**CONTRACT NO. M.W.S.B. 1434**

**Grand Beach Provincial Park Lagoon**

**ADDENDUM NO. 2**

Date: August 1, 2018

**1** | **DETAIL**  
TYPICAL ANCHOR BOLT

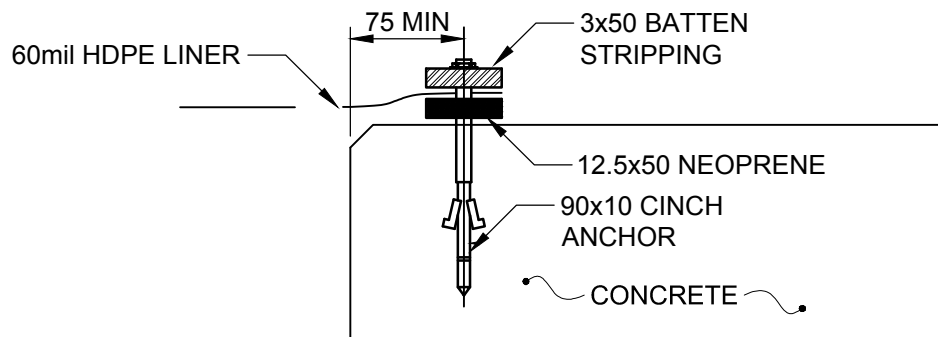
2.1 **Add** the attached Detail 1 as the detail referenced for Typical Anchor Bolt in Detail 4 of Drawing C-4002.
